METROPOLITAN GOVERNMENT OF NASHVILLE AND DAVIDSON COUNTY

STAFF RECOMMENDATION
Ransom Avenue/Byron Close Development
100 and 117 Ransom Avenue
August 19, 2015

Application: New construction--infill
District: Elmington Place Neighborhood Conservation Zoning Overlay
Council District: 25
Map and Parcel Numbers: 104100O00500CO, 104100O00600CO
Applicant: Barlow Builders
Project Lead: Melissa Baldock, melissa.baldock@nashville.gov

Figure 1. Site map.

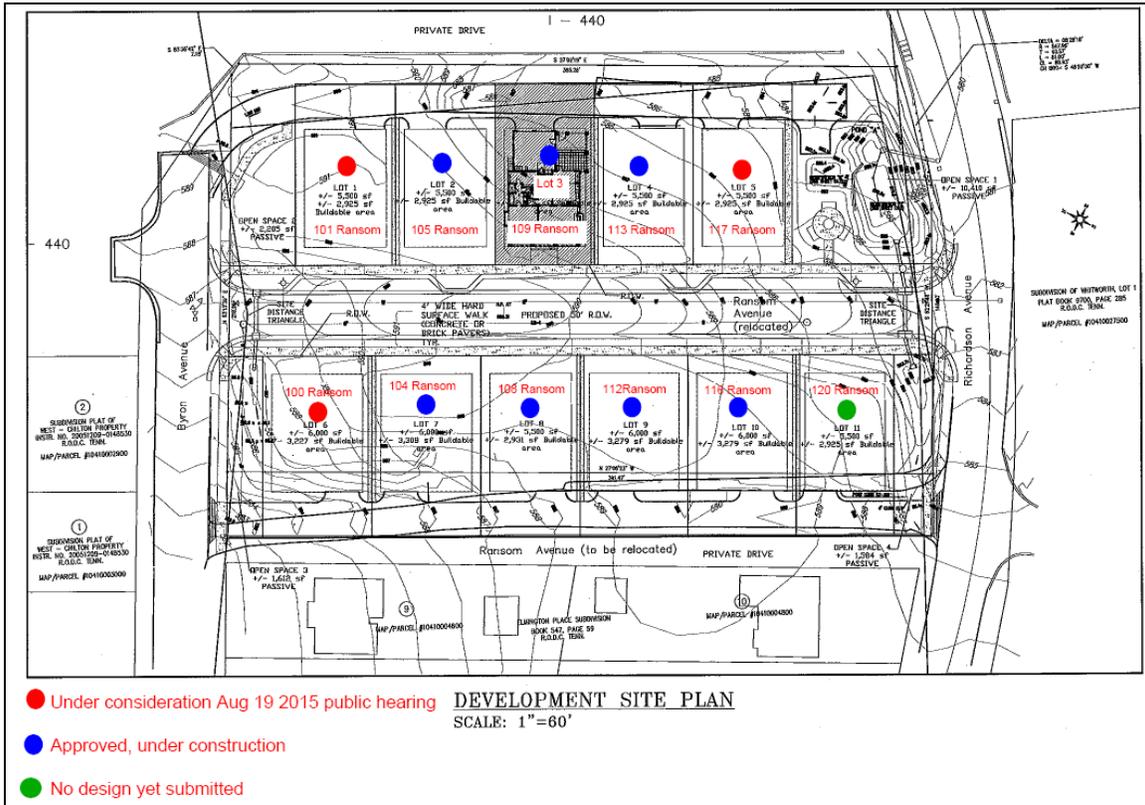
Background: Ransom Avenue/Byron Close is an eleven unit residential SP development (BL2008-149) located on the previous site of Ransom School, close to I-440 and West End Avenue. To date, the Commission has reviewed and approved the design of seven of the eleven houses (Figure 1). Construction on these houses has begun (Figures 2 & 3). The applicant now proposes designs for two more of the infill developments with a third proposal on this month's agenda.

SITE PLAN
 OF
LOT 5, BYRON CLOSE SUBDIVISION
 PLAT DOC #20131018-0108864
NASHVILLE, DAVIDSON COUNTY, TN.

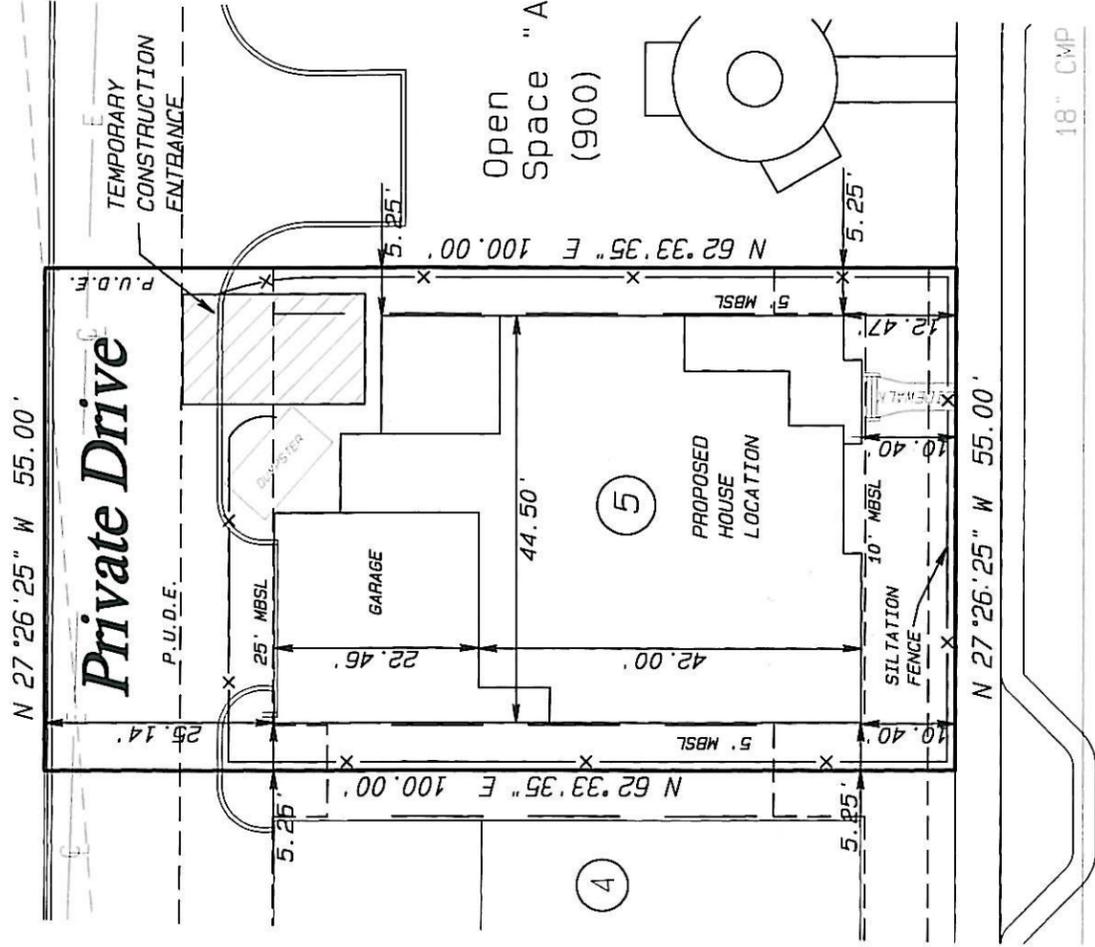
Lot 5’s primary cladding material will be brick with a stone foundation. It will have smooth-face, five inch (5”) siding in its gable field on the right elevation. Lot 6’s primary cladding material will be lap siding, and staff asks that the siding exposure be five inches (5”) or less. Vertical board-and-batten will be used in the gable fields. Stone will be used for the foundation material and for the column bases. Staff will want to approve all brick and stone samples prior to the materials being purchased and installed.

Lot 5 is located off of Richardson Avenue. Its right side façade will be adjacent to the required open space for the development, and therefore this façade will be visible from Richardson Avenue. The house’s primary orientation is towards Ransom Avenue, but it addresses Richardson Avenue with a wrap-around porch that is six feet (6’) deep and a secondary entrance facing Richardson Street. In addition, the house’s roof forms and fenestration pattern on the right elevation further serve to provide secondary orientation towards Richardson Avenue. Because this lot is set back behind the open space for the development and it will be over sixty feet (60’) from the street, its side street façade does not need to appear as a front elevation like the Commission has required for Lots 1 and 6. Staff finds its orientation to be appropriate.

SITE PLAN

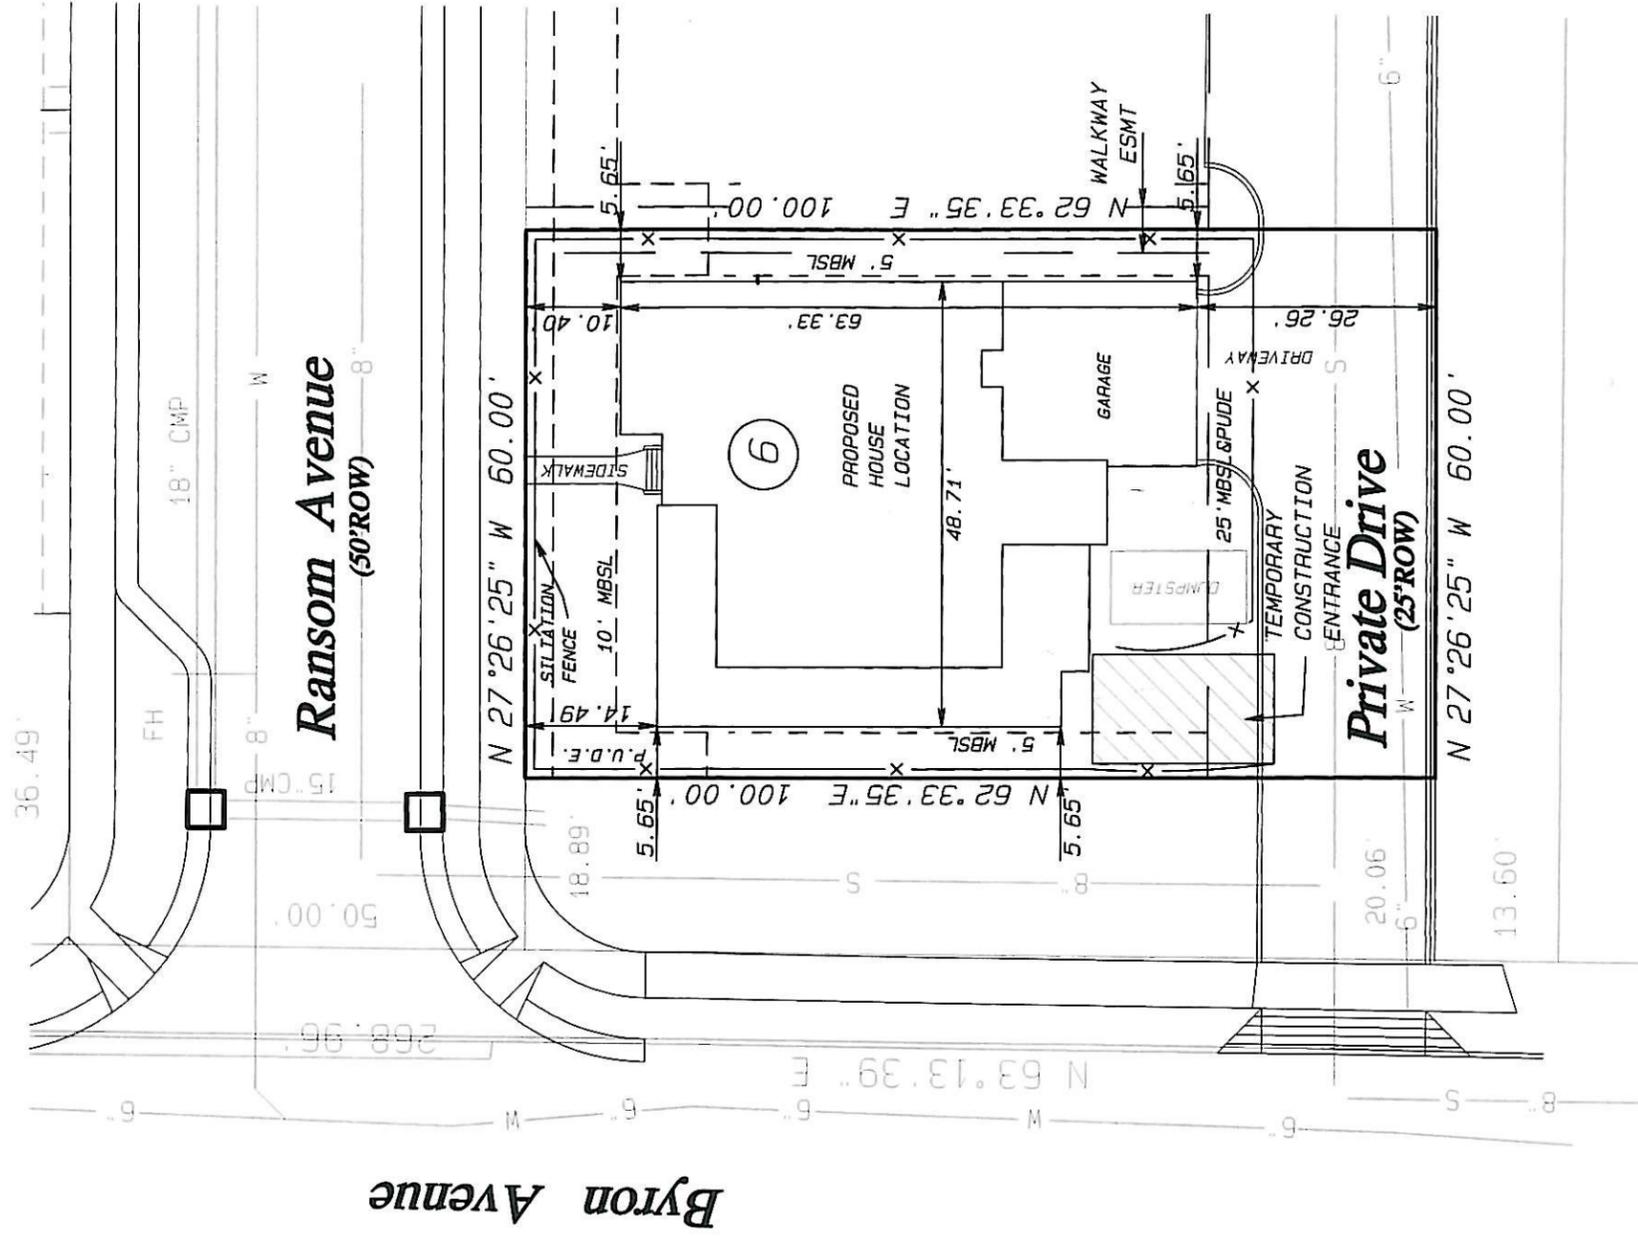
Staff notes that the house for Lot 6 is wider than the others because it is on a wider lot of sixty-feet (60’). With the porch, the house is forty-eight feet, eight inches (48’8”) wide, but the front wall of the house is just forty-two feet, two inches wide (42’2”). The widths of historic homes in the area range from thirty-two feet (32’) to forty-eight feet (48’), so staff finds that the proposed width meets the historic context.

Orientation: Lot 6 is located on the edge of the Ransom Avenue development, with side facades that face Byron Avenue. The Commission has determined in the past that these lots should have side street facades that look like front facades in order to address Byron Avenue. Lot 6 successfully addresses both Ransom Avenue and Byron Avenue with a wrap-around porch that is six feet (6’) deep and entries on both facades that have the look of a primary residential entry. In addition, the fenestration and roof pattern of the Byron Avenue façade give it the appearance of a primary façade.
